<div>Owner/Applicant DCR/PHOENIX HOMES</div> <div>Telephone # 723-9227 Plan # 27M-47 Project nameWHITE TAIL RIDGE Civic Address131 FRANK FISHER CR. House model: SPRINGFIELD C</div>		<div>Bldg. Ht.7.67m Lot coverage10.6% Scale1:250 Sod Area1886m² Asphalt Area128m²</div>	<div><div></div><div><div><div>LOT 142</div><div>SITE/GRADING PLAN WHITE TAIL RIDGE PH.IV</div></div></div></div>
<div>CHECKED/APPROVED BY: T.L.MAK ENG. REV. JAN. 15/24 – CB</div>		<div>INDIVIDUAL LOT GRADING REVIEW SUMMARY FOR SITED HOUSE AS COMPARED WITH OVERALL SUBDIVISION PLAN</div> <div>NOTE: THIS PLAN IS NOT A SURVEY PLAN OR SUBDIVISION PLAN WITHIN THE MEANING OF PLANNING ACT. THIS PLAN IS FOR REFERENCE ONLY AND IS PRELIMINARY IN NATURE. ALL DIMENSIONS SHOWN ARE APPROXIMATE. E.O&E.</div>

Kollaard File # 240020 – LOT142

Re: Proposed Single Family Dwelling, 131 Frank Fisher Crescent, Lot # 142 White Tail Ridge, Arnprior, Kollaard Associates File # 240020

With regard to structural issues only, Kollaard Associates has reviewed the following drawings:

GROUND FLOOR

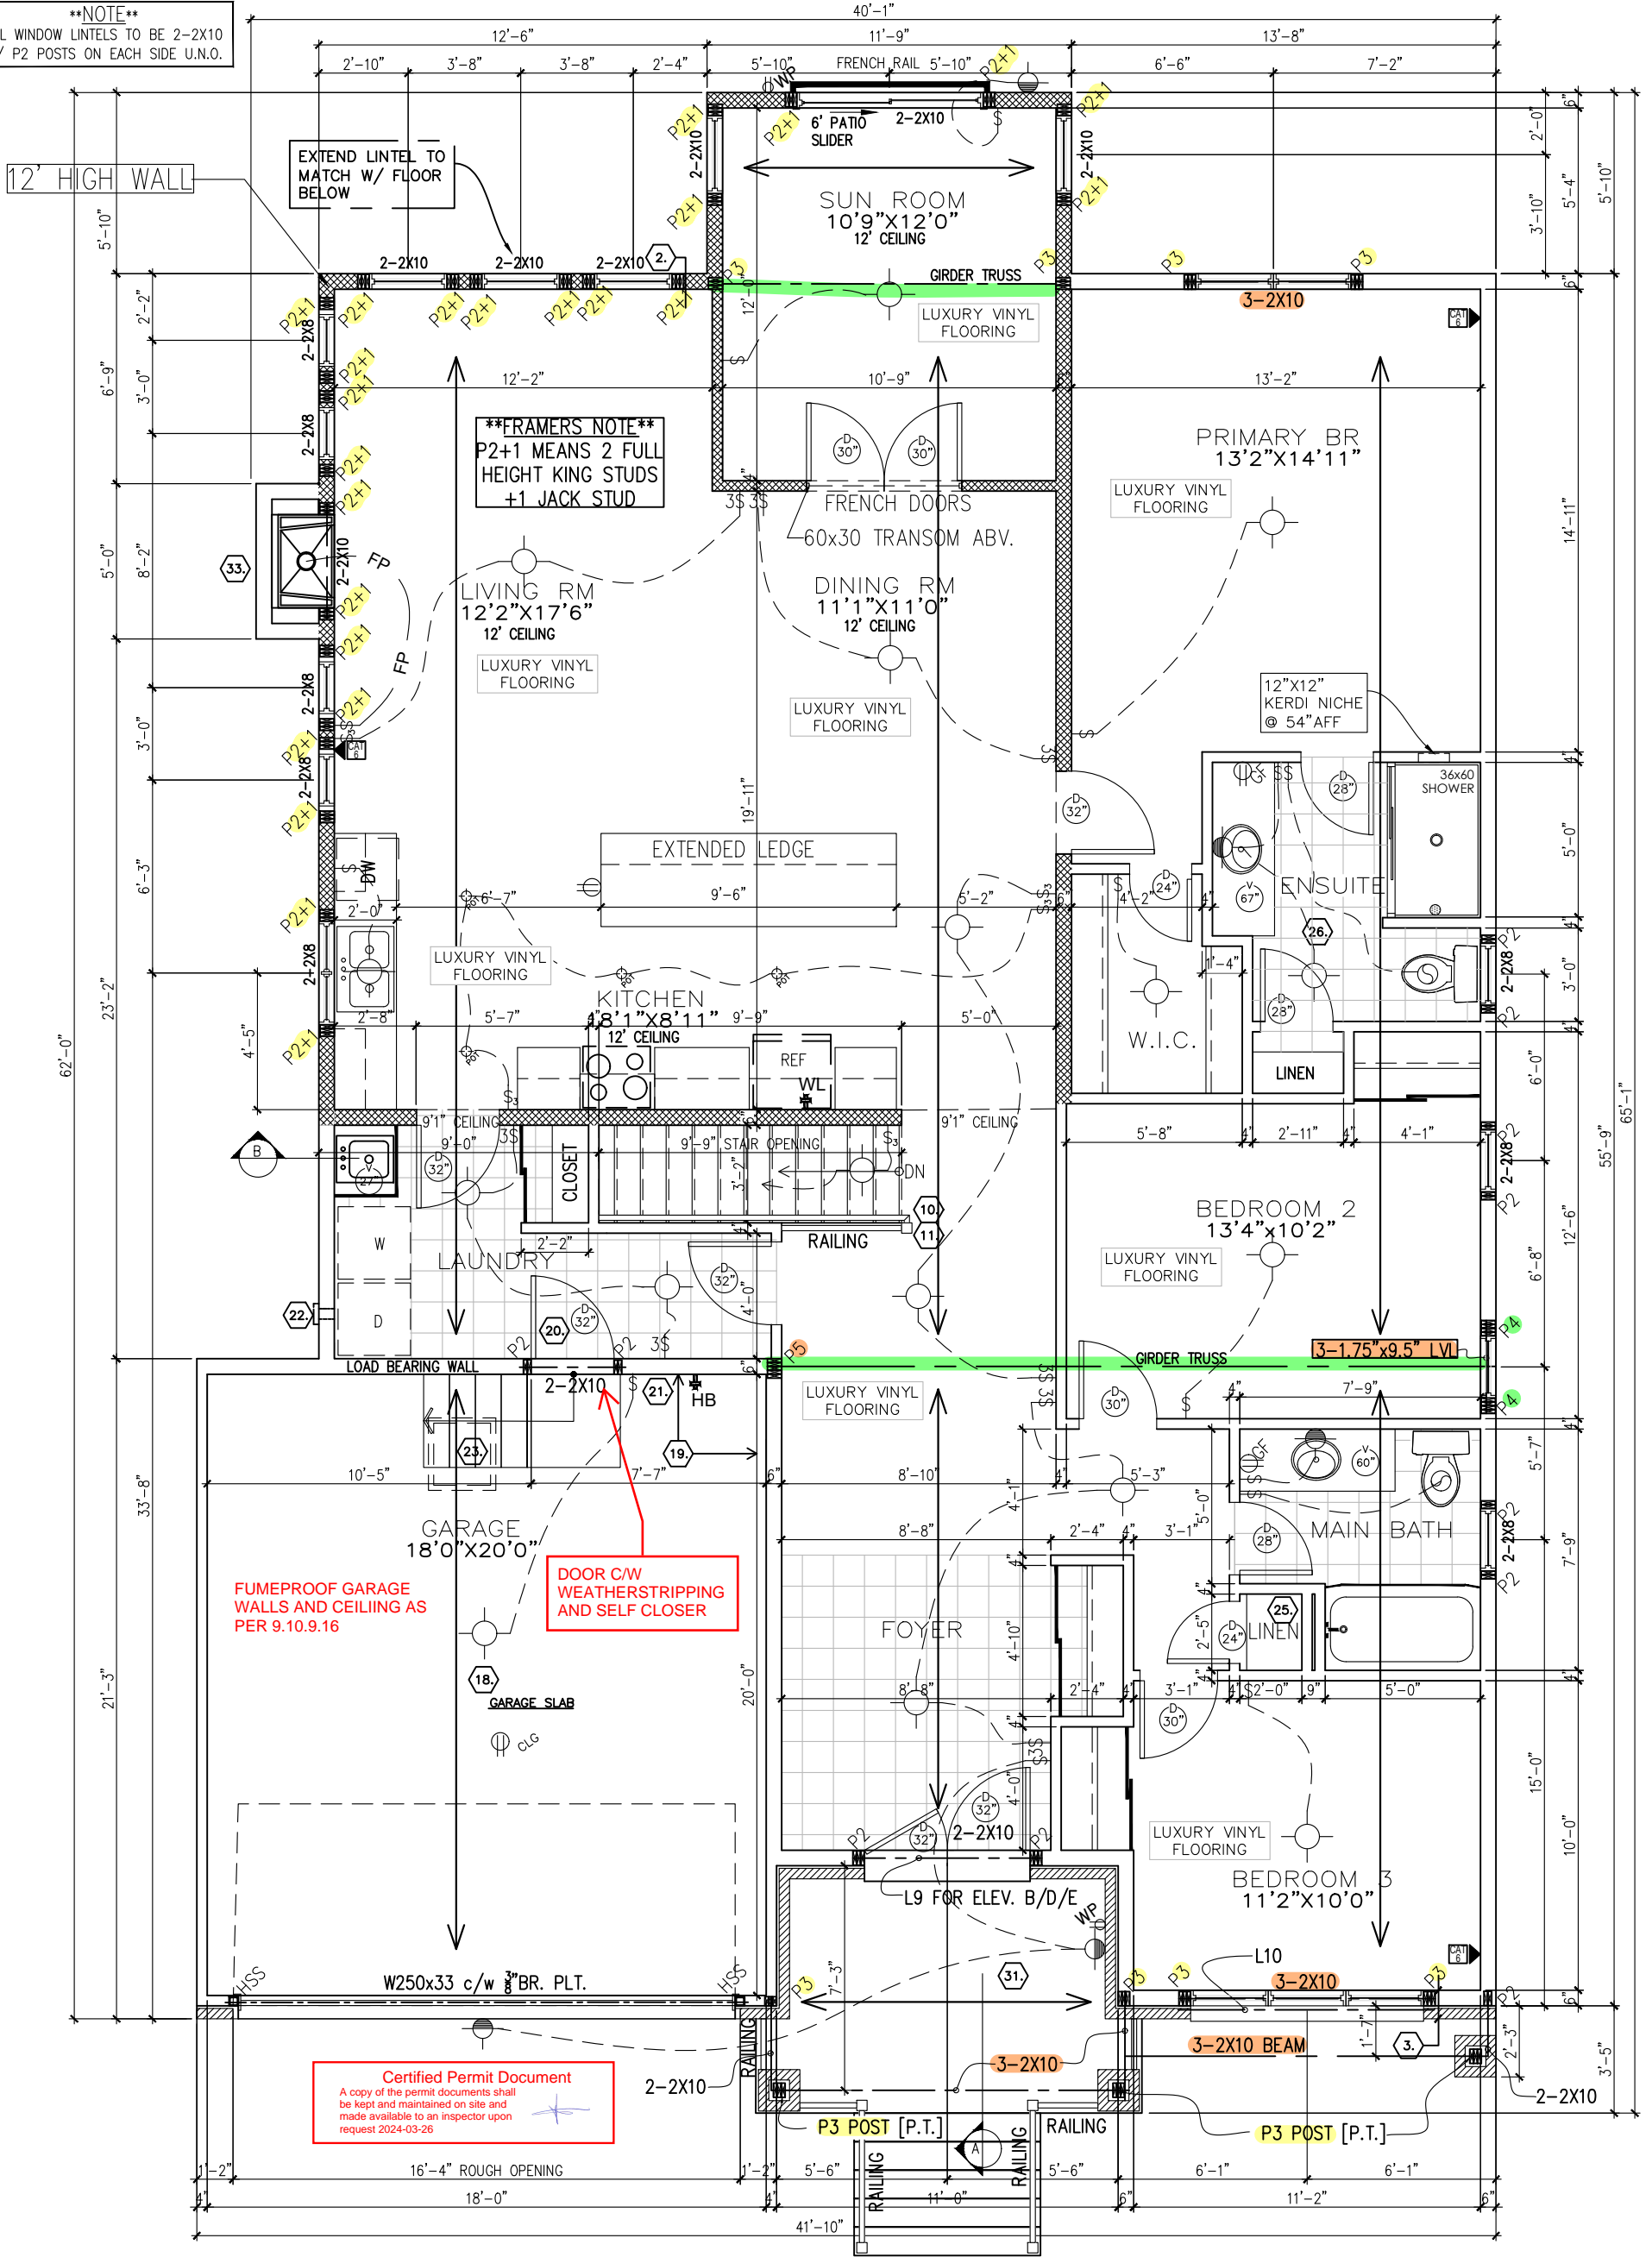
Ground Floor Plan – Pages # 3:

1. It is the opinion of Kollaard Associates that the proposed beams, lintels and supporting posts shown on Phoenix Homes Pages # 3 are adequate.
2. The proposed tall wall construction (including posts supporting lintels within the tall wall) noted on Phoenix Homes Pages # 1 is adequate.
3. Posts supporting girders may consist of built up 2x6 posts as indicated on Phoenix Homes Pages # 3 and are laterally supported by plywood or OSB sheathing (i.e. posts form part of sheathed exterior walls unless noted).
4. Truss design is by others.

RIGHT SIDE ELEVATION C

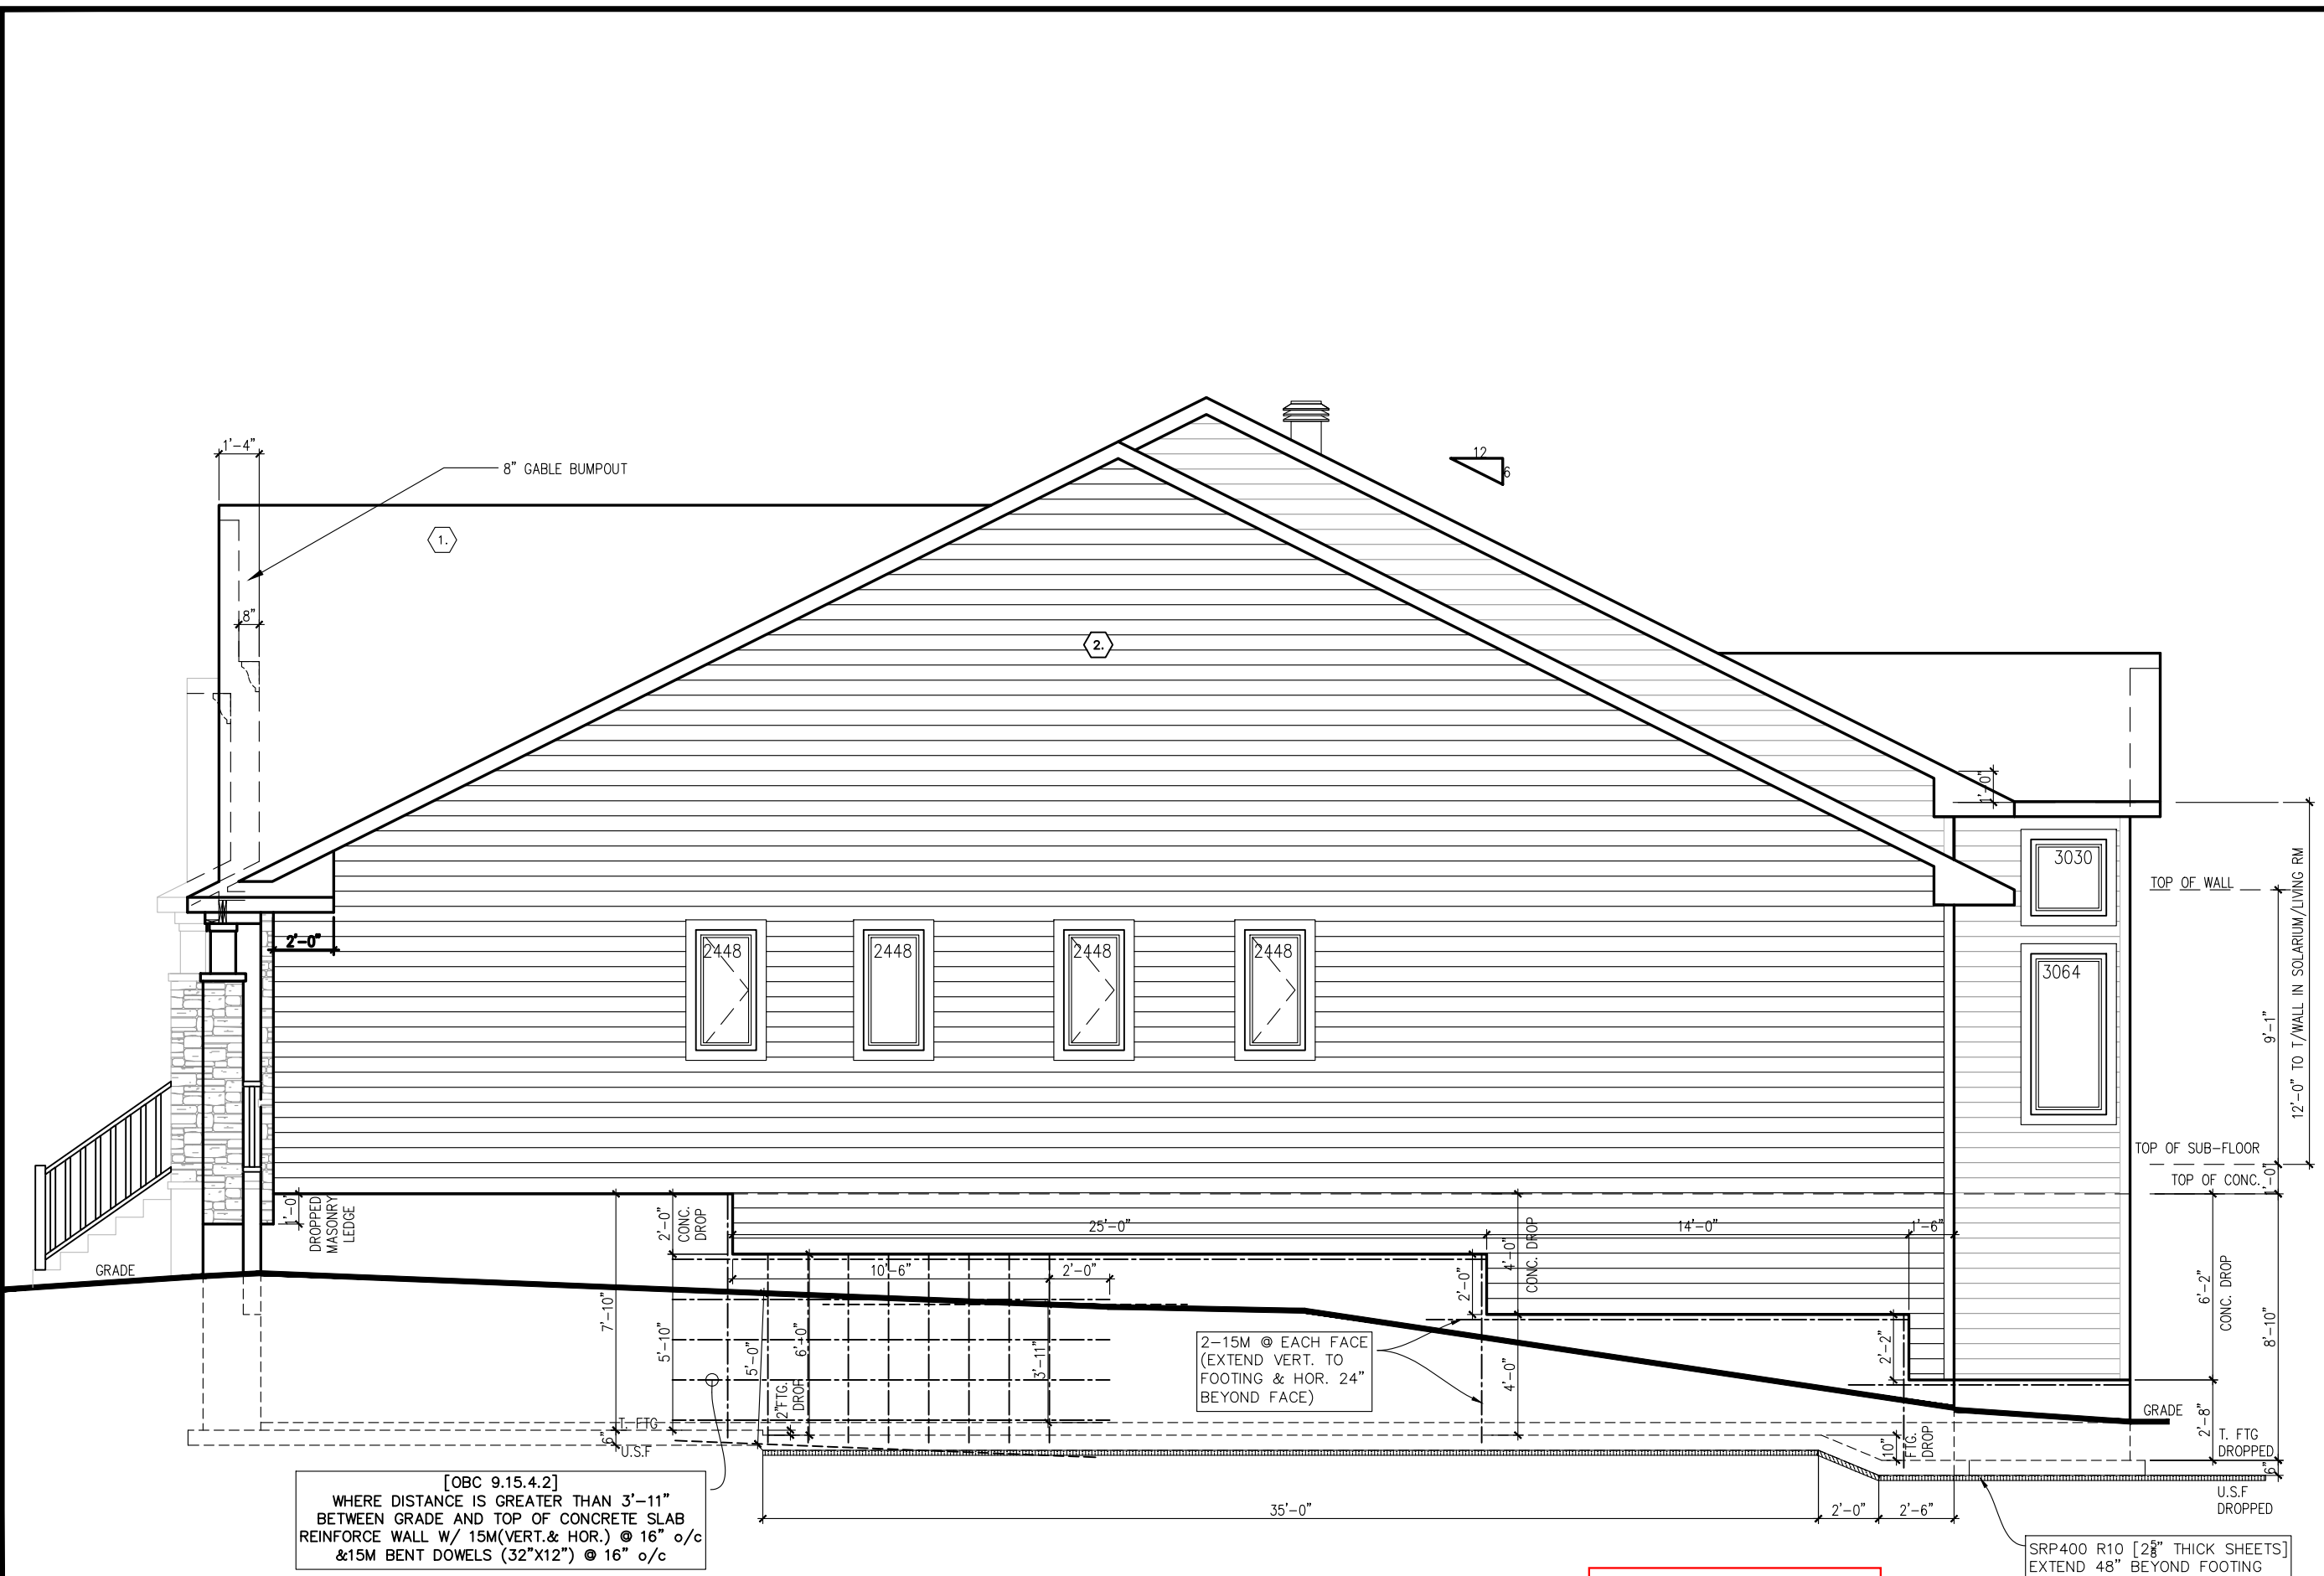
10. Where the grade difference between the basement slab and the exterior finished grade exceeds 3'-11" along the right side, the proposed foundation reinforcement noted on Phoenix Homes Pages # 6 and 7 are adequate to withstand the lateral earth pressures.
